This Addendum forms part of the Tender Documents and amends the Tender Documents as described below.

- 2.1 Revise Project address on cover page and titleblocks to read " 1910 Simcoe St N, Oshawa, Ontario"

SIMCOE VILLAGE RENOVATIONS PHASE 2 - 2019 DURHAM COLLEGE	SCALE	DWG. NO.
CANOPY DETAILS REF DWG A1.1 CANOPY SECTION, DETAILS	AS NOTED	ADD-6
MOFFET & DUNCAN ARCHITECTS INC. 5052 DUNDAS ST. WEST TORONTO ONT. M9A 1B9 TELEPHONE (416)-239-2775	JOB # 1910

ADD-3

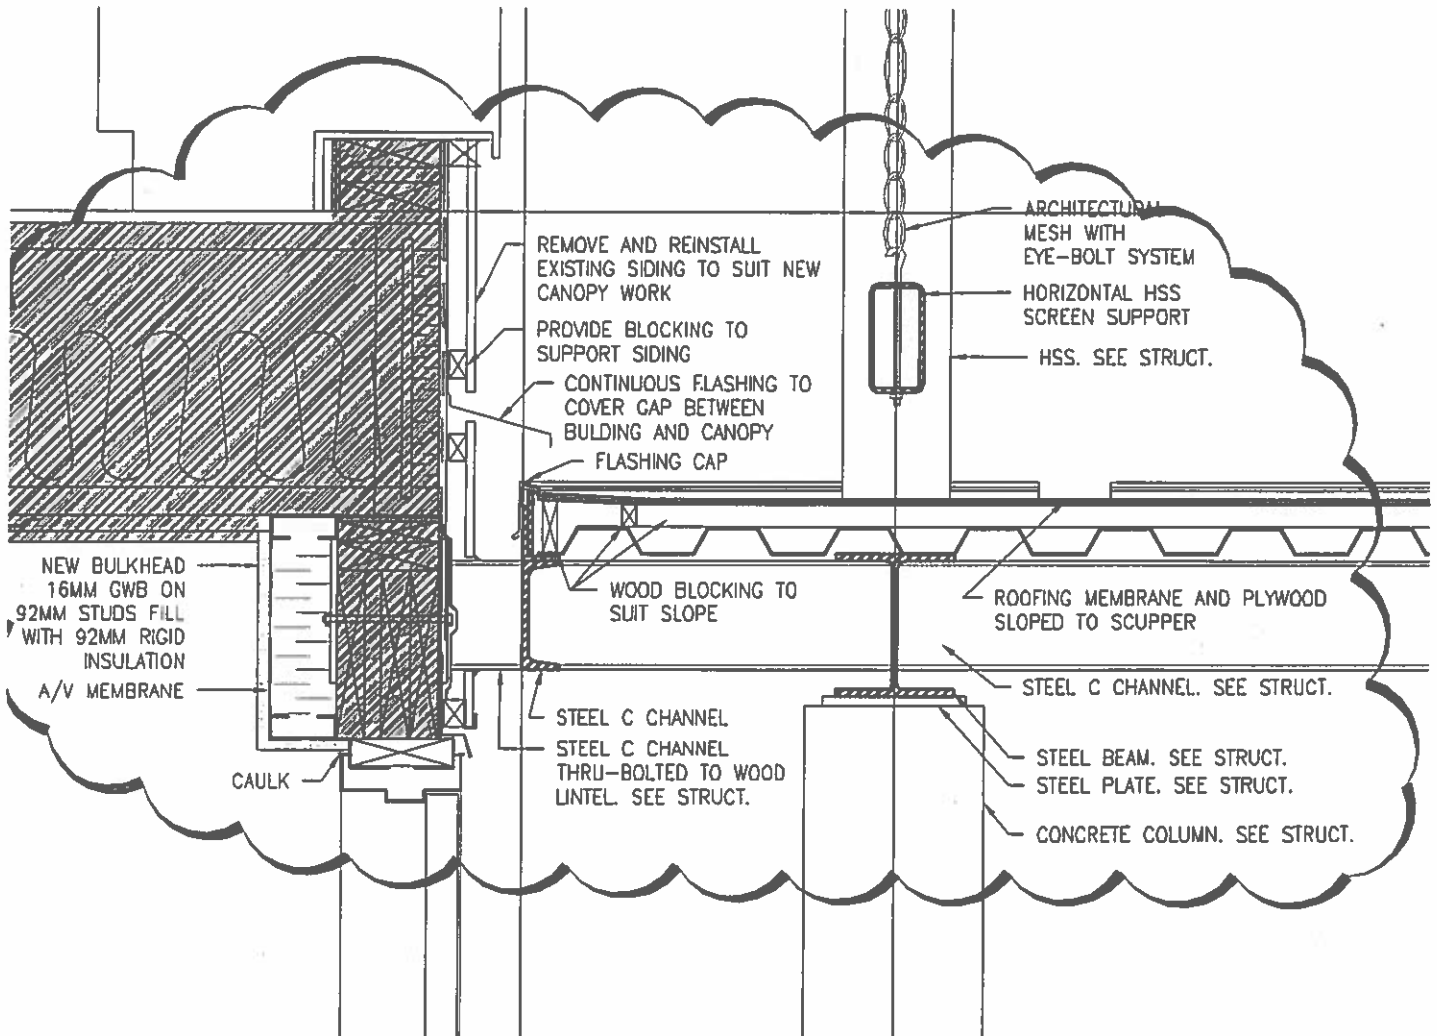
- .1 Revise grading, culvert retaining stones and asphalt walkway on 2/A1.0 as per ADD-1.
- .2 Revise scupper and sloped roofing on top of canopy on 4/A1.0 as per ADD-2.
- .3 Revise height of canopy on 6/A1.0 as per ADD-3.
- .4 Revise guardrail on 6/A1.0 as per ADD-3.
- .5 Replace drawings 1/A1.0 as per ADD-20.

3/A1.1 DETAIL AT CANOPY

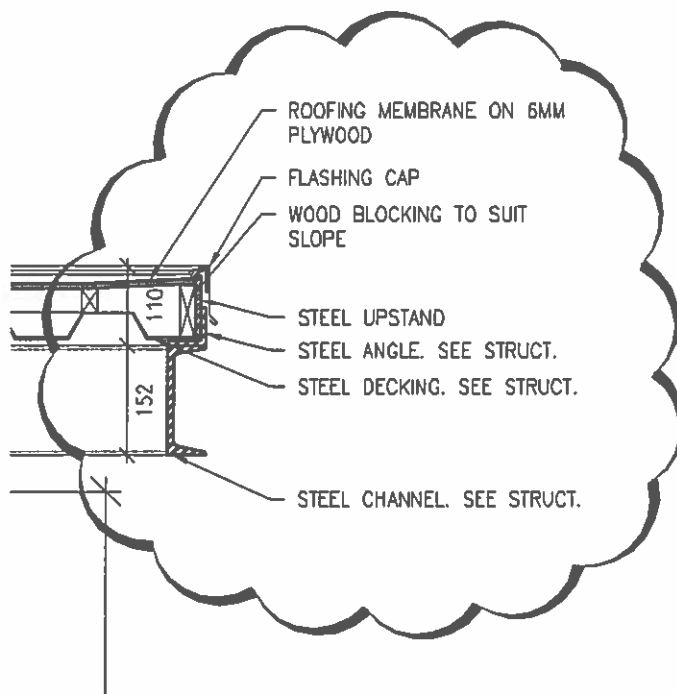
- .1 Revise 1/A1.1 to show insulation and non-compacted fill at new ramp landing as per ADD-4.
- .2 Revise ramp, walkway, guardrail and handrail on 1/A1.1 as per ADD-4.
- .3 Revise 3/A1.1 as per ADD-5.
- .4 Revise 4/A1.1 as per ADD-6.
- .5 Add 5/A1.1 as per ADD-6.

PART OF 1/A2.1 PARTIAL BASEMENT PLAN
AT IT ROOM

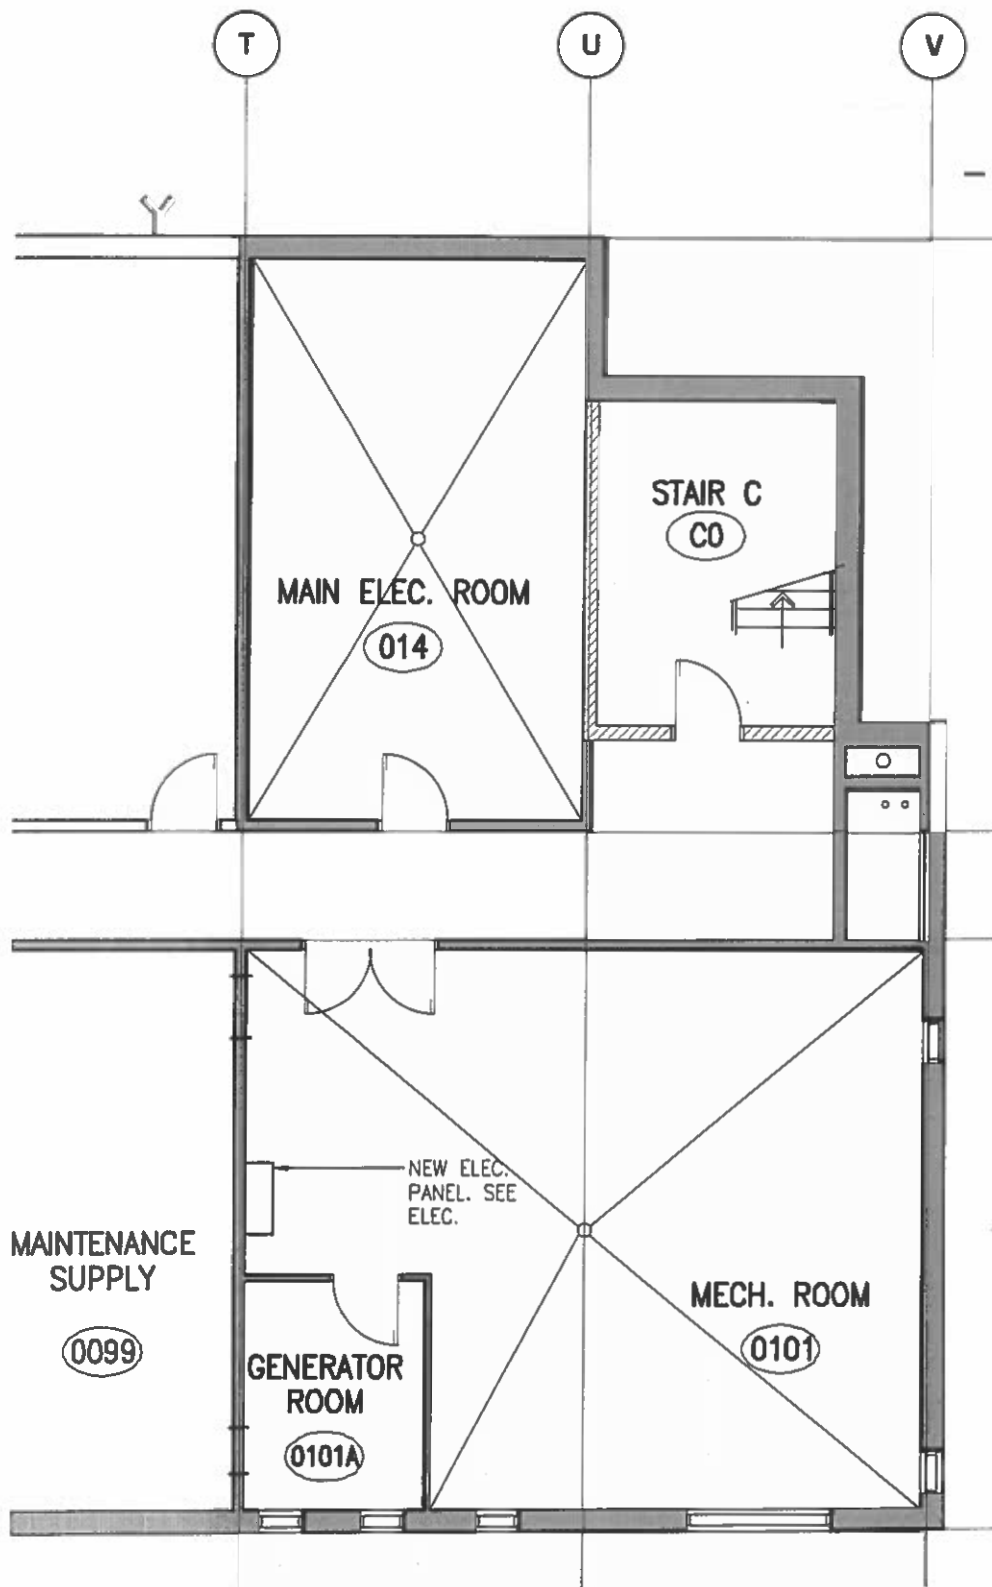
- .1 Revise 1/A2.1 as per ADD-7 and ADD-8 to show location of new Mechanical and Electrical work in IT Room 0096 and Mech Room 0101.
- .2 Revise 3/A2.1 as per ADD-9 to show new electrical chase, new condensing unit and new wall-mounted phone.

1/A2.2 PARTIAL SECOND FLOOR DEMOLITION PLAN

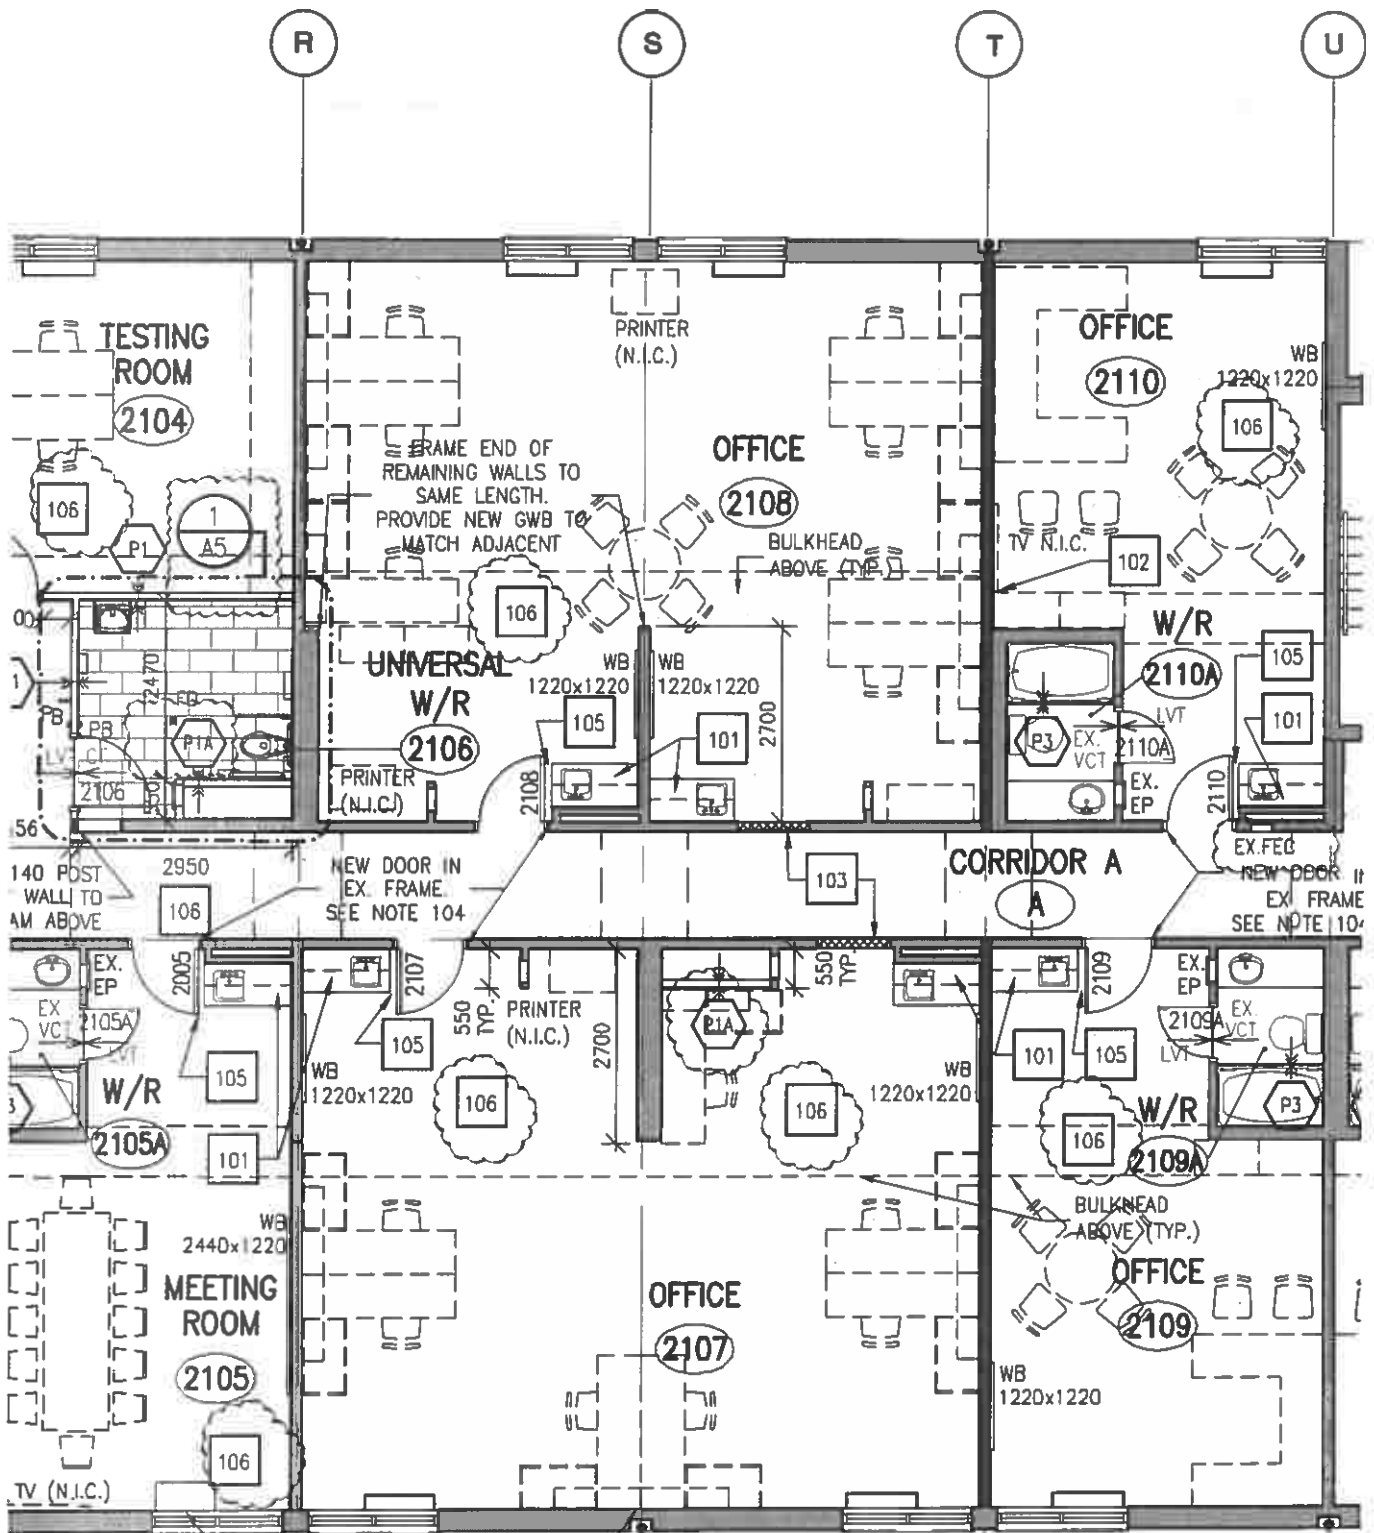
- .1 Revise Reference Demolition Note 104 to read:
"REMOVE TEXTURED WALL COVERING IN SUITES. REMOVE ALL ADHESIVES AND RESIDUE AND PREPARE EXISTING DRYWALL TO RECEIVE NEW PAINTED FINISH AS PER RFS. COORDINATE WITH ELECTRICAL CONTRACTOR REMOVAL OF EXISTING GYPSUM BOARD TO ACCOMMODATE NEW WIRING AND CONDUIT. INSTALL NEW GYPSUM BOARD TO MATCH EXISTING WHERE REMOVED"
- .2 Delete Reference Demolition Note 113.
- .3 Revise 1/A2.2 to remove existing door between Lobby 2000 and Corridor A as per ADD-10.
- .4 Add Reference Renovation Note 106 to read:
"INSTALL NEW 6MM WOOD UNDERLAYMENT BOARD OVER EXISTING SUBFLOOR IN ALL CORRIDORS AND ROOMS RECEIVING NEW LVT FLOORING."

ADD-14

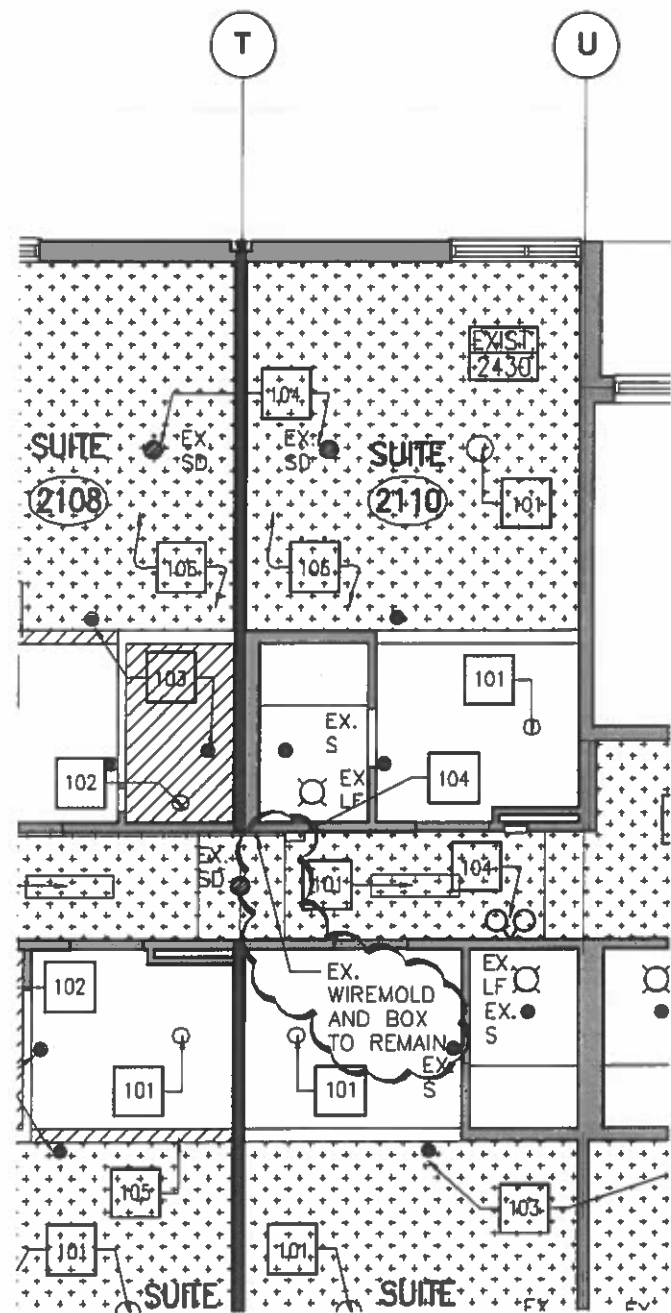
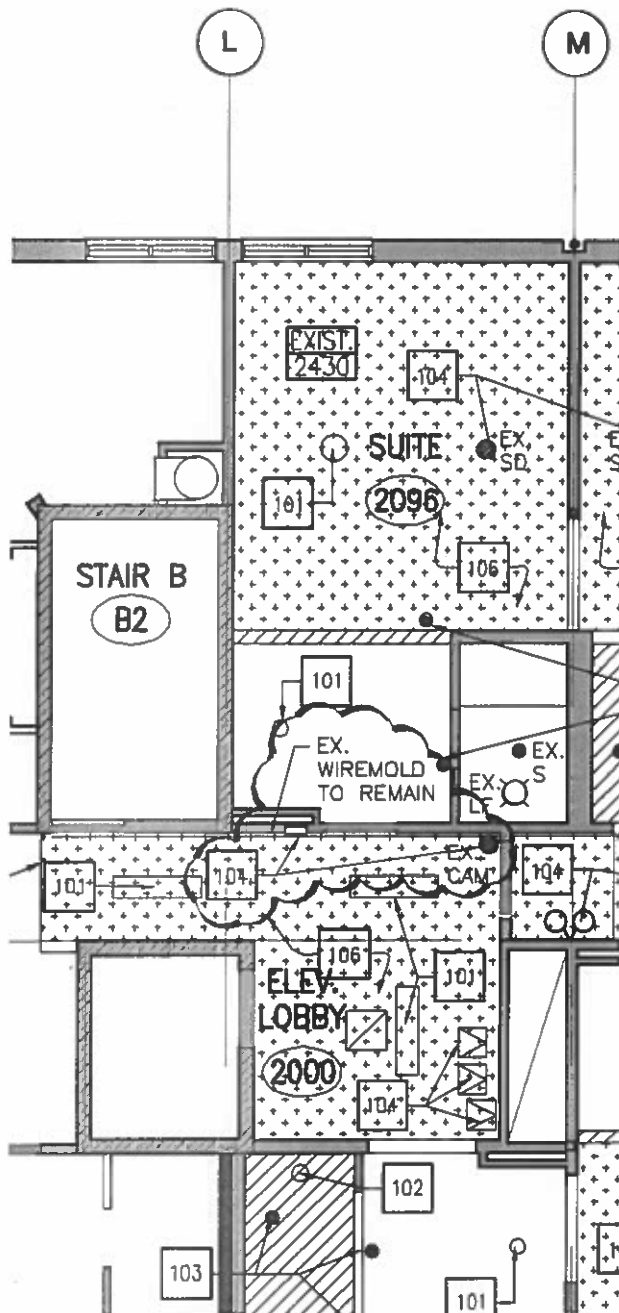
- .1 Revise Door Schedule as per ADD-13.
- .2 Add Partition Types as per ADD-14.

ADD-16

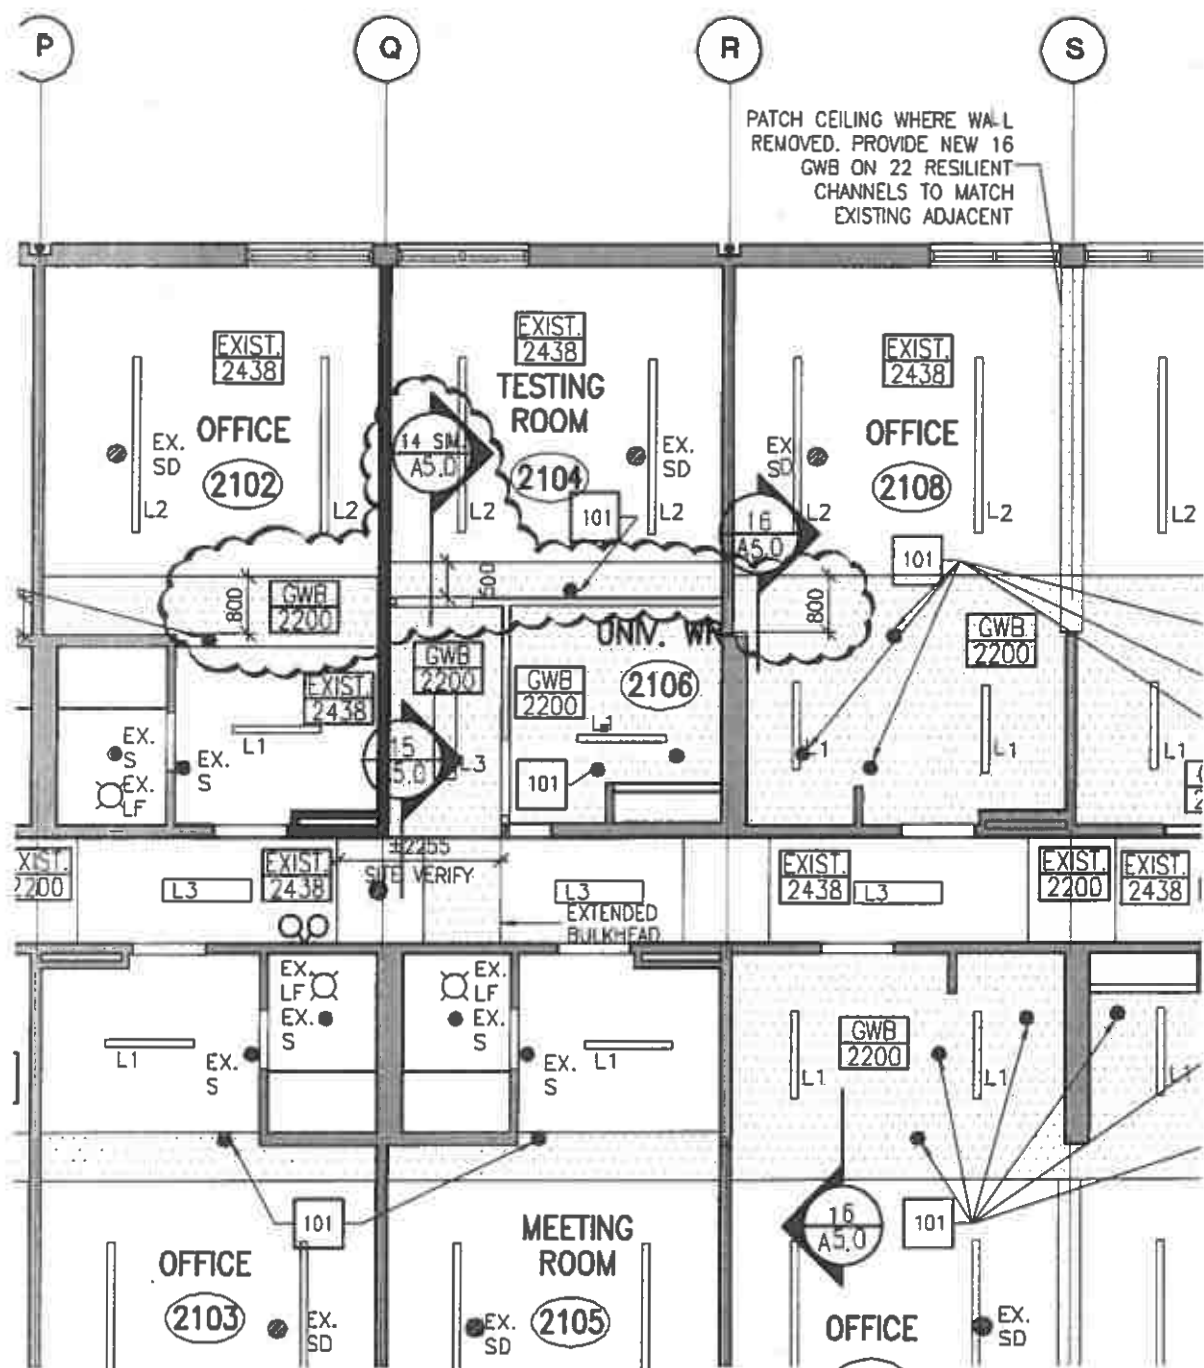
- .1 Revise 1/A4.0 as per ADD-15 to show existing camera, wiremold and speakers to remain.
- .2 Revise 2/A4.0 as per ADD-16 to show new ACT ceiling and revised light fixtures in storage rooms 2097 and 2097A, chase wall in 2094B, Conduit in 2094A and revised bulkhead in 2096.
- .3 Add section reference at canopy to 2/A4.0.
- .4 Revise bulkhead in Office 2102, Testing Room 2104 and Office 2108 as per ADD-17.

SIMCOE VILLAGE RENOVATIONS PHASE 2 - 2019 DURHAM COLLEGE MILLWORK AT MEETING ROOM 2095 REF DWG A5.0 WASHROOM DET, MILLWORK...	SCALE AS NOTED	DWG. NO. ADD-18
MOFFET & DUNCAN ARCHITECTS INC. 5052 DUNDAS ST. WEST TORONTO ONT. M9A 1B9 TELEPHONE (416)-239-2775	JOB # 1910

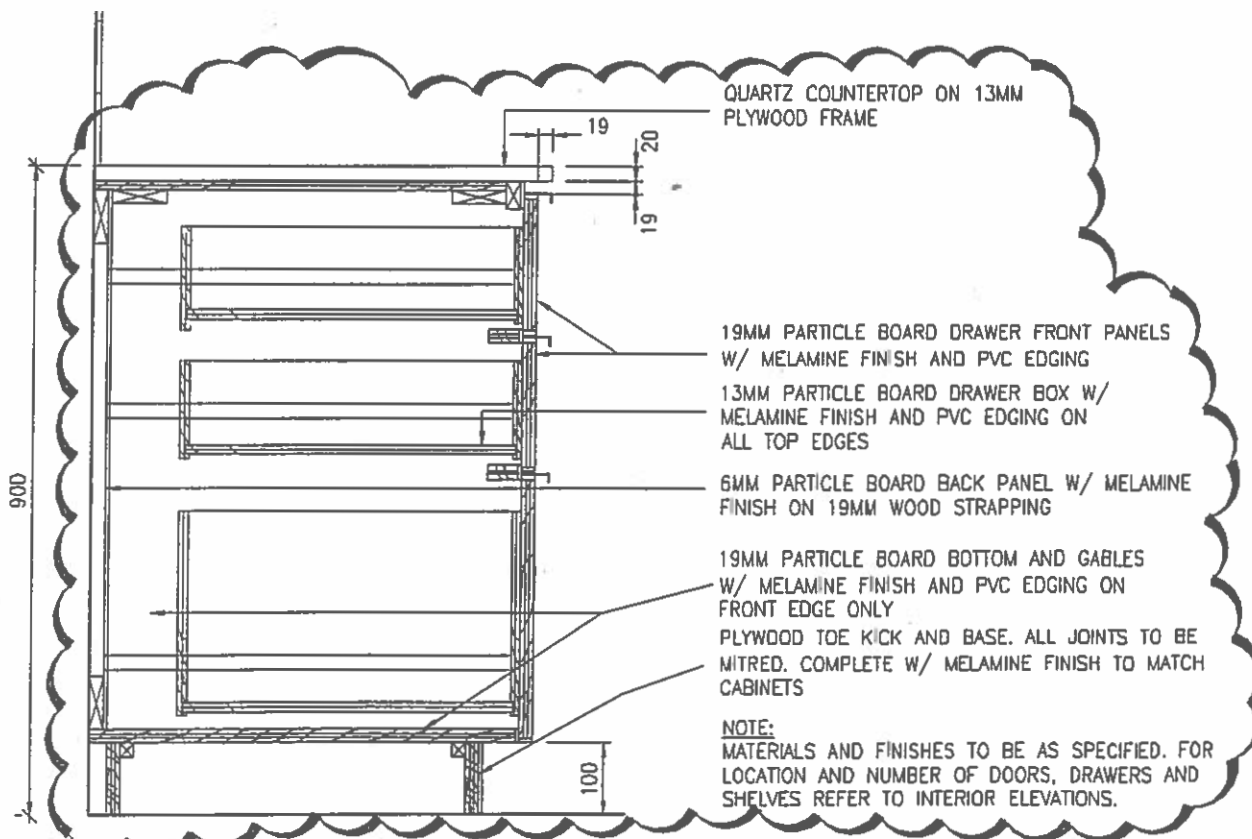
- .1 Delete references to "solid surface countertop" and replace with "quartz countertop".
- .2 Revise Meeting room 2095 kitchenette as per ADD-18.
- .3 Add detail 17/A5.0 as per ADD-19.
- .4 Revise 16/A5.0 Bulkhead in offices as per ADD-21.
